**Central Queensland Coal Project
Appendix 10g – 2018 Waterway
Barrier Works Map Amendment
Request**

CQC SEIS, Version 3

Review of waterway barrier works mapping intersecting the Central Queensland Coal Project (ML80187)

Figure 1
ML and waterway barrier mapping

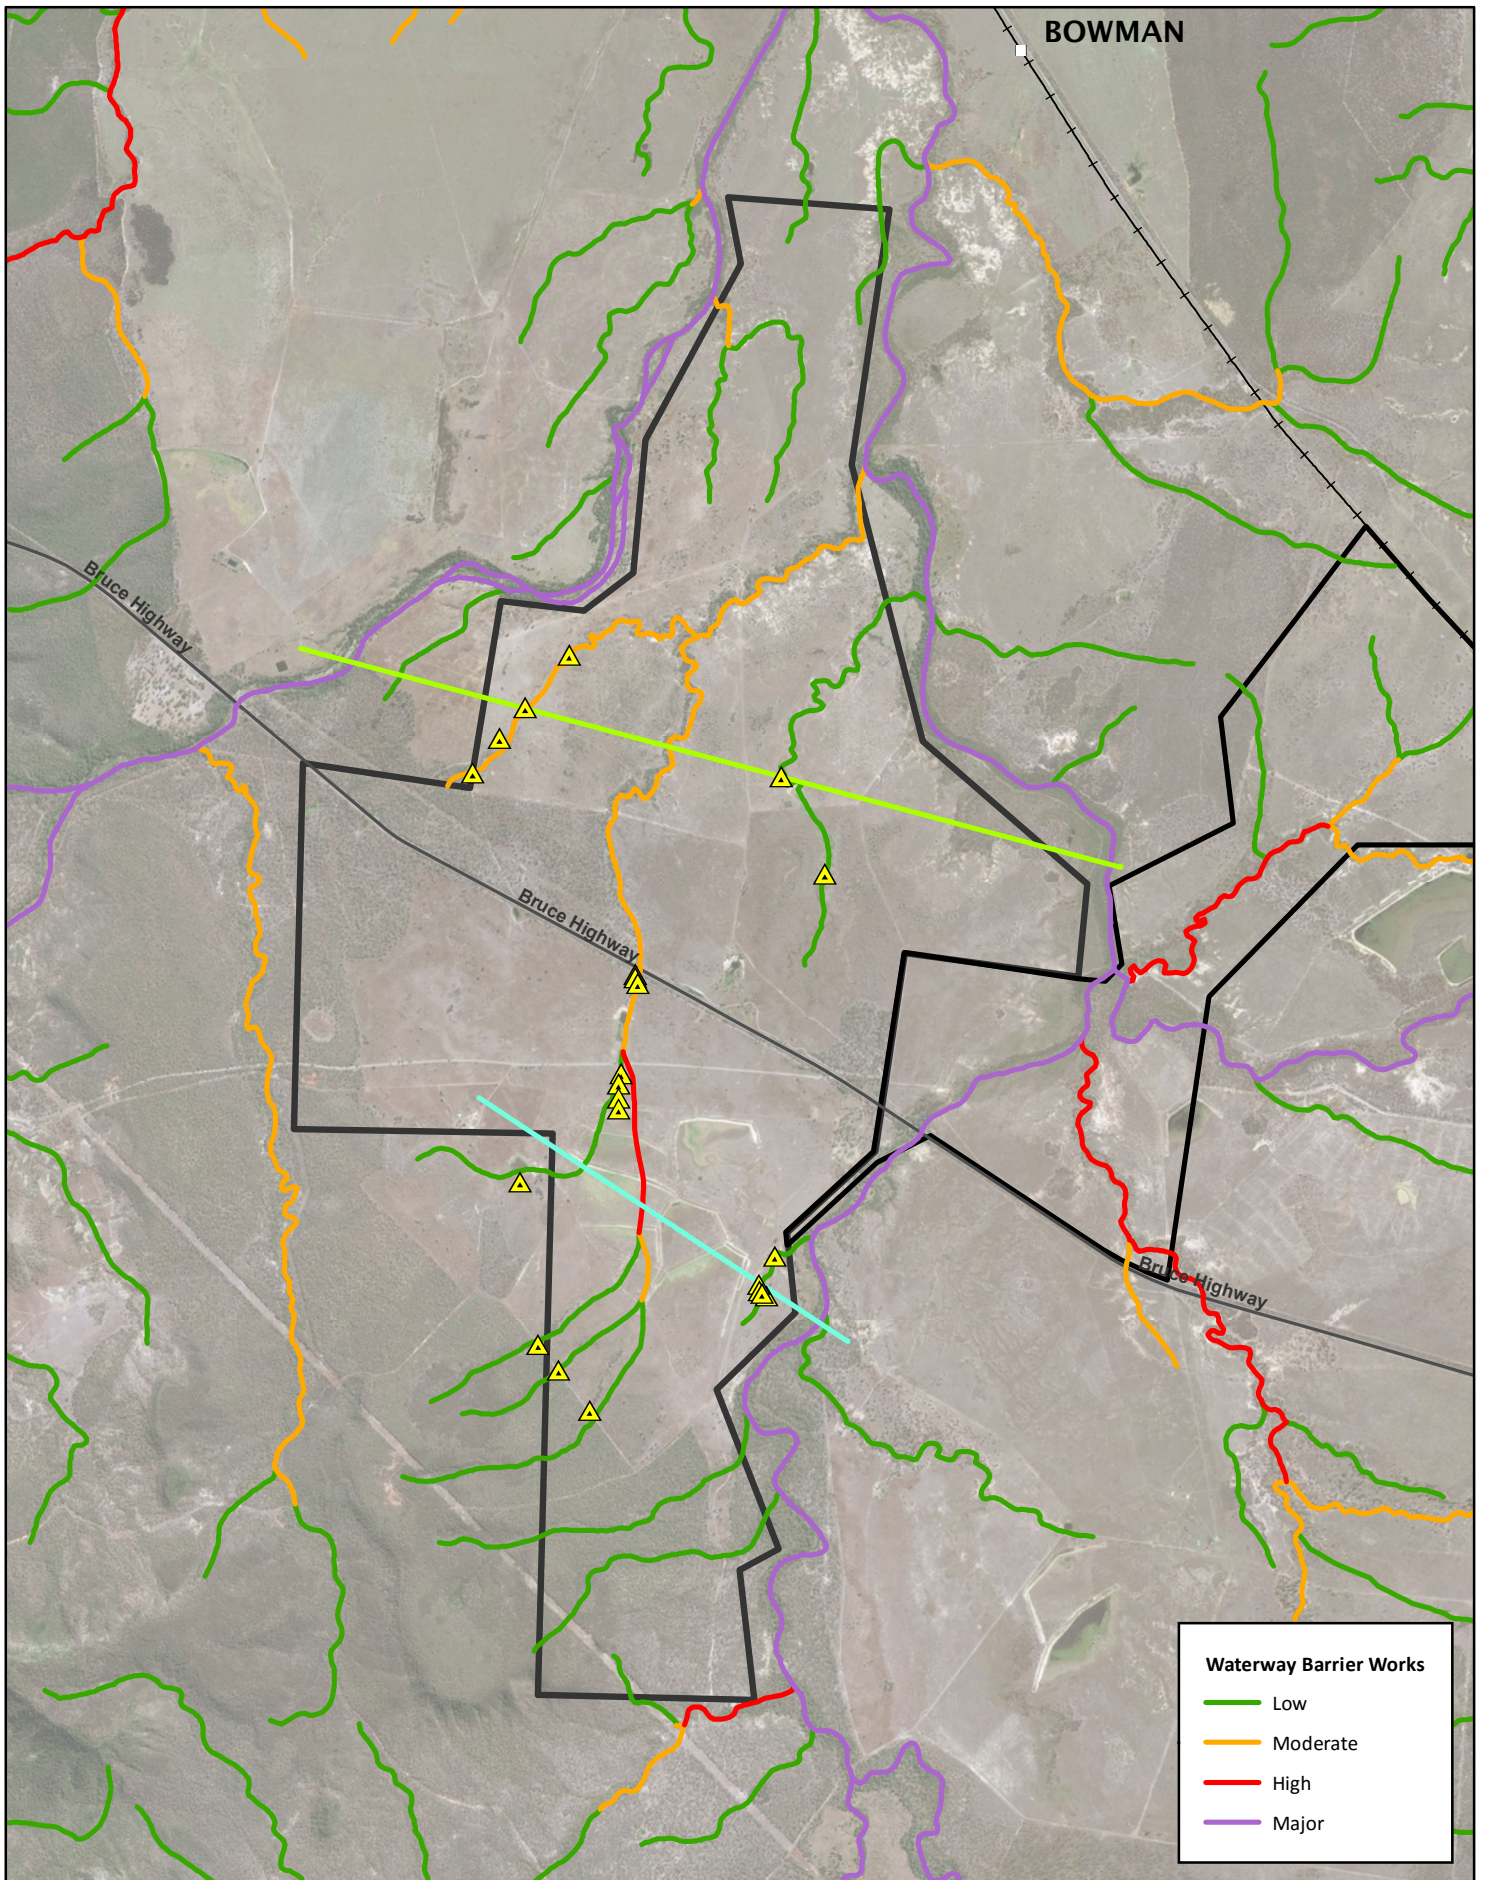
The focus of this assessment is on those waterways as indicated by survey points on Figure 1. Site photograph points were established where a channel was observed in close proximity to the lines indicated by the waterways mapping layer. The text in the following (results) section refers to specific sections of creek line associated with the numbered survey points.

1. The Project ML is bisected by the Bruce Highway (labelled in Figure 1). The waterways upstream (south) of a dammed area to the south of the highway have been heavily modified. A number of berms have been constructed across the original waterways in order to create flooded pasture areas for cattle grazing which has effectively removed the channel. When wet the bermed areas have become densely vegetated with an introduced weed – Olive Hymenachne (*Hymenachne amplexicaulis*) (listed as a category 3 weed under the State’s *Biosecurity Act 2014*). The bed and banks have been removed and are no longer continuous in this system as indicated in aerial imagery and site inspections. Refer Attachment 1 for site photos associated with several survey points associated with this system – WB8, WB9, WB11, WB12 and WB13.

In summary, the proponent believes the following features are mapped as incorrect and request an assessment from the DAF on the validity of the waterway barrier mapping:

- All mapped waterways located upstream of the dammed area located to the south of the Bruce Highway (to the north of survey point WB8d);
- The western tributary of the central channel bisecting the ML which is currently mapped as ‘moderate risk’; and
- The minor tributary off Deep Creek in the east of the ML which currently mapped as ‘low risk.’

Figure 2 Comparative cross-section of watercourse crossings in area from LIDAR (Deep Creek shown at top)

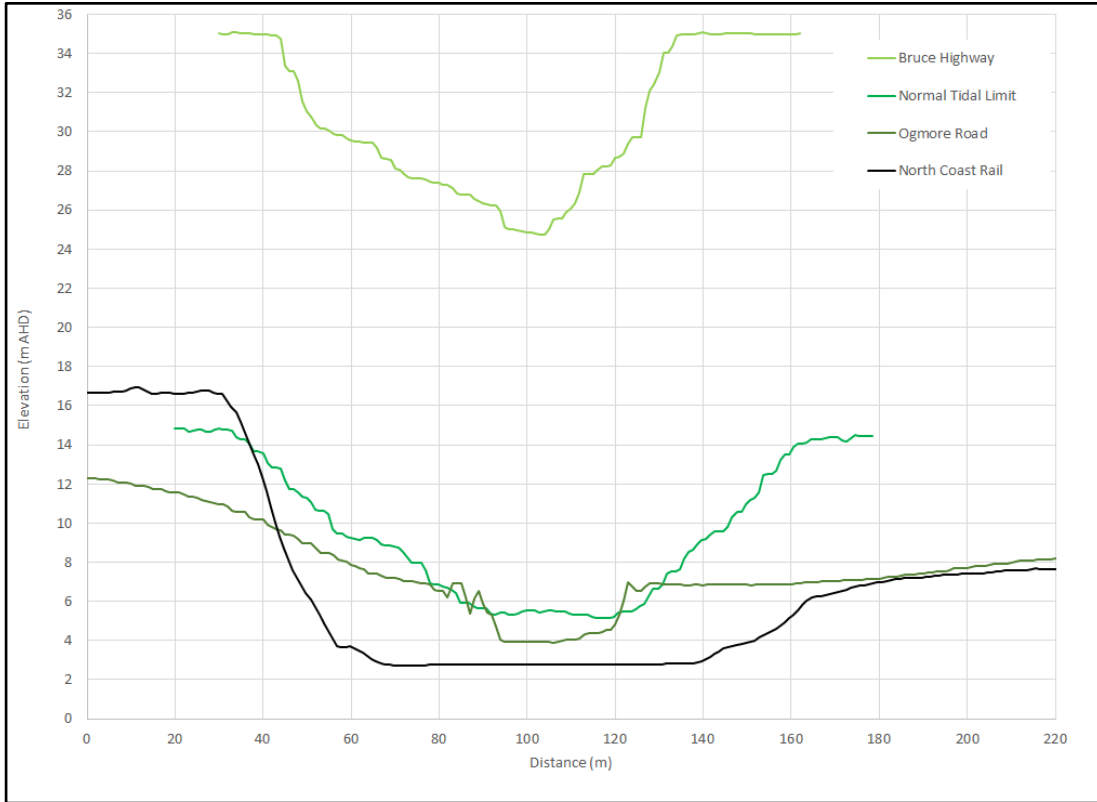
The mapped drainage features sit on the Deep Creek floodplain and outside the effective flow area. The catchment area of the subject waterways is small and topography relatively flat. Deep Creek itself is a steeply incised channel and highly ephemeral. Figure 2 below shows the channel of Deep Creek is approximately 10 m below the adjacent bank height where the Bruce Highway crosses the creek (based on recent LIDAR survey).

Figure 3 Elevational cross-section of waterway barrier risk features to north of the Bruce Highway

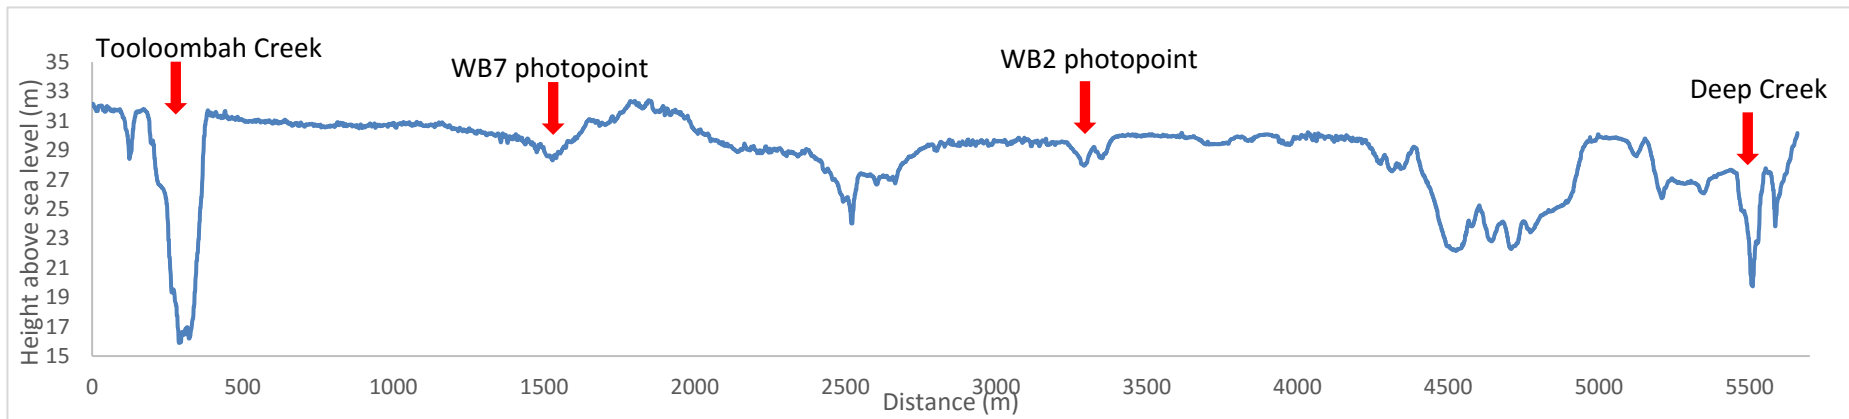
Figures 3 and 4 provide a comparative elevational cross-section of the drainage features crossing the subject property. The cross-sections are depicted from above in Figure 1 for visual reference to the landscape. The cross-section to the north of the highway (Figure 3) crosses (approximately) through two of the photo points depicted in Attachment 2. The cross section at WB7 demonstrates the depth of the feature is 2.5 m below the surrounding landscape with channel slopes extending 100's of metres from the deepest point. The cross section at WB2 crosses the feature twice where an 'S' bend occurs. The depth of the feature is less than 2 m below the surrounding landscape with gentle channel slopes and an overall width of approximately 70 m.

Figure 4 Elevational cross-section of waterway barrier risk features to south of the Bruce Highway

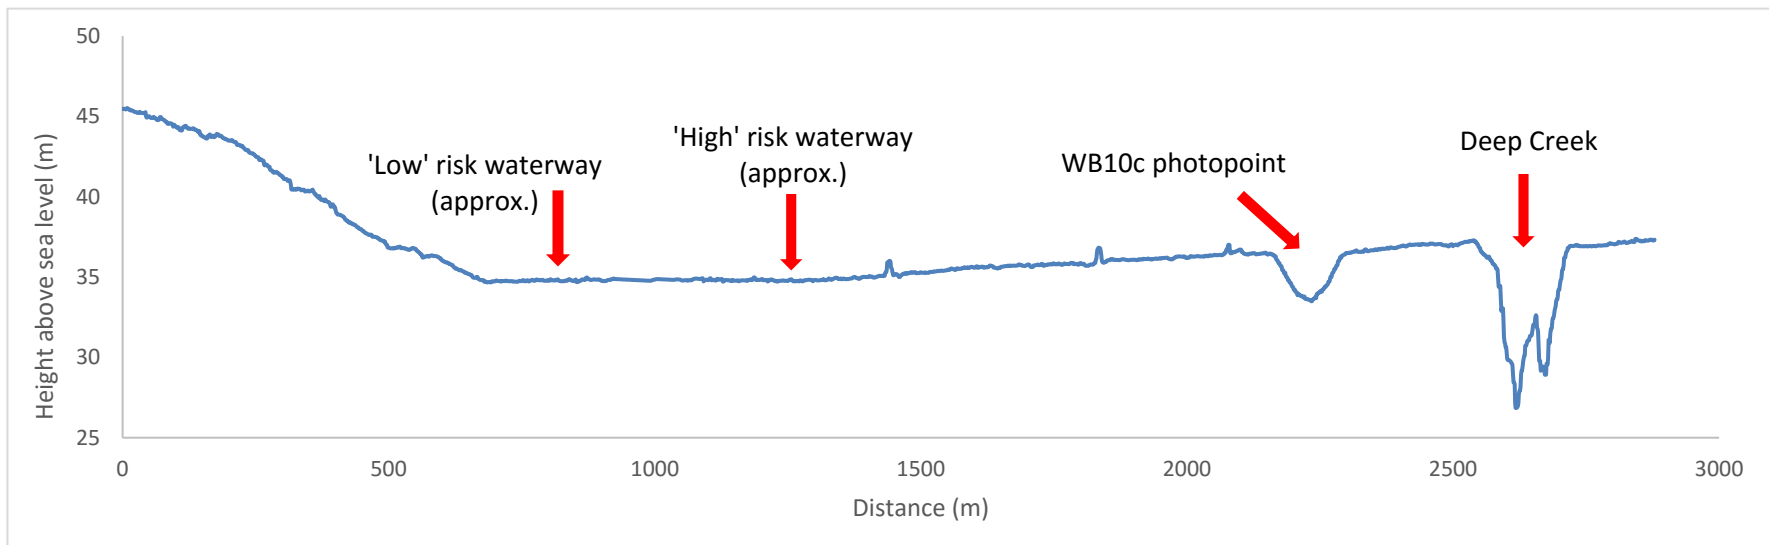
The cross-section to the south of the highway (Figure 4) shows the approximate position of the mapped 'risk' features demonstrating there is no channel at all in these areas. The cross section at WB10c (refer Attachment 1) demonstrates the depth of the feature is 3 m below the surrounding landscape with gentle channel slopes extending across an overall width of over 100 m. There is no evidence of a bank on this feature.

Figure A1
Waterway barrier assessment points
(south of Bruce Highway) for Styx Project

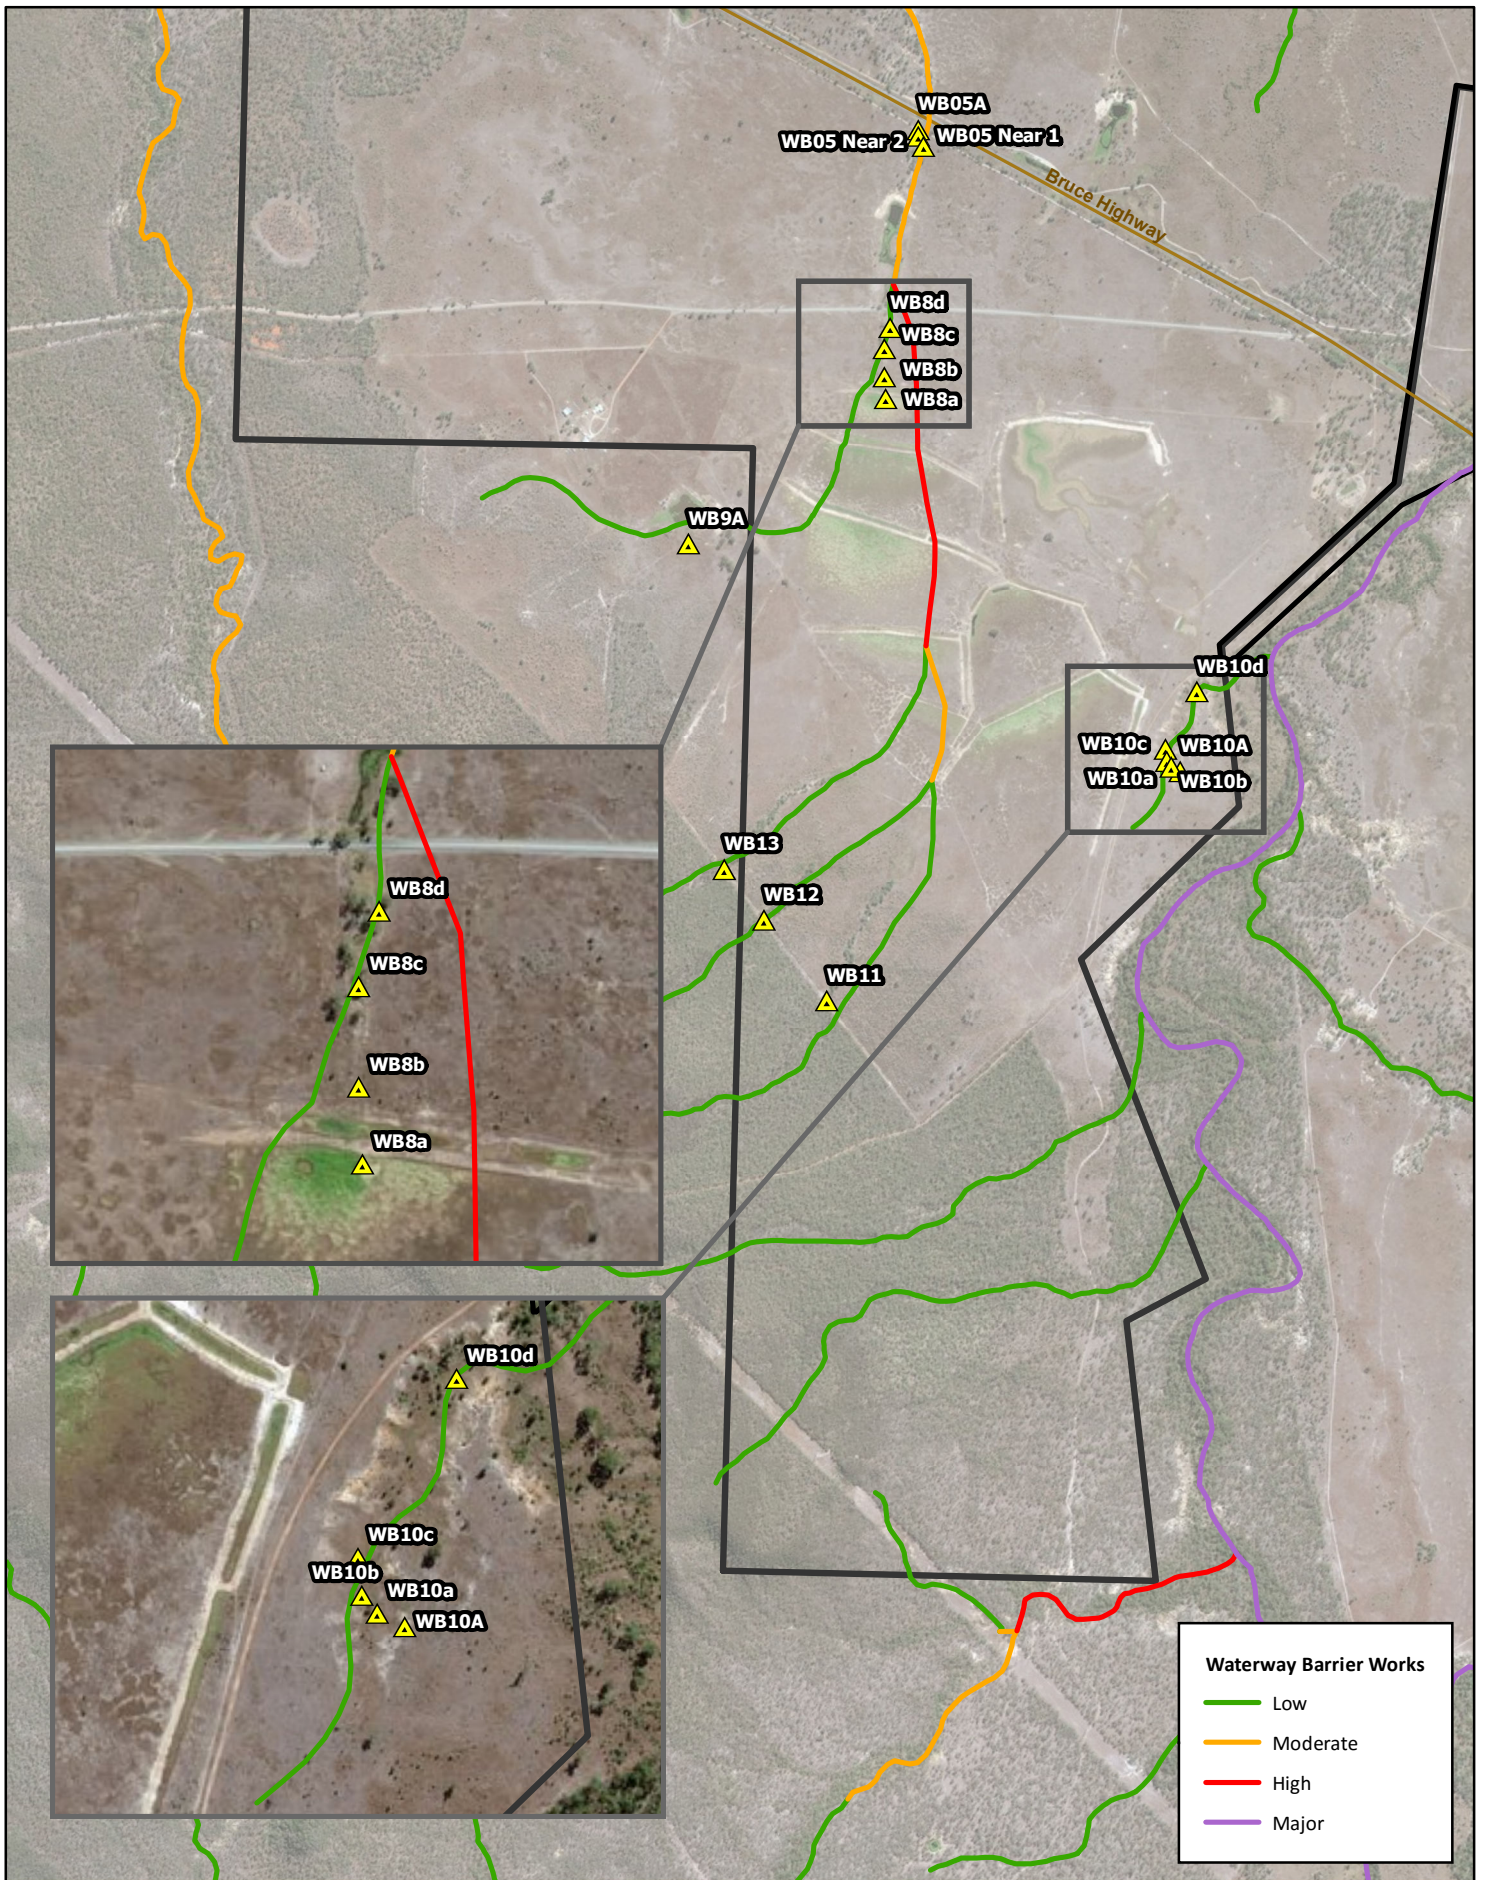
The observations in this attachment pertain to all mapped waterways located across the site to the south of the Bruce Highway (refer Figure A1). It is proposed here that these waterways (including those sections located upstream of the project) do not provide habitat for fish.

The following images depict the landscape features directly north and south of the bermed area which includes two mapped drainage lines including a 'high risk' (red) area and 'low risk' (green) polyline (indicated on Figure A1 as survey points labelled WB8a-d). Note, aerial imagery and site inspection shows there is now no channel in the red area. An indistinct channel occurs in the area of the green line which becomes more defined closer to the downstream dammed area north of survey point WB8d. There is approximately 240 m between the points WB8a and WB8d.

The following photos depict a point located upstream and south-west of the bermed areas. The point is located near a farm dam adjacent to a mapped 'low risk' waterway (indicated on Figure A1 as survey point WB9). Aerial imagery indicates a low overflow area emanating from the dam at this point. However, there is no 'channel' indicated in the site photos or on aerial imagery.

The following photos depict points located along 'low risk' waterways (indicated on Figure A1 as survey points WB11, WB12 and WB13) located upstream of the bermed areas and survey points WB8a-d. These waterways drain a low rocky hill/plateau and are highly ephemeral. The photos indicate very minor channelisation (at best described as a drainage area) and do not represent potential or temporary fish habitat. Photos taken 27 September 2018.

The following depicts a minor channel/gully (described as ‘low risk’ under the mapping) draining a very small catchment which is separate from the catchment described by the previous survey point photos and feeds into Deep Creek (indicated on Figure A1 as survey points labelled WB10a-d). This area comprises a relatively steep eroded gully which does not have any defined bed or banks or provide any potential pooled areas before draining to Deep Creek. There is approximately 260 m between the points depicted - WB10a and WB10d. Photos taken 31 August 2018.
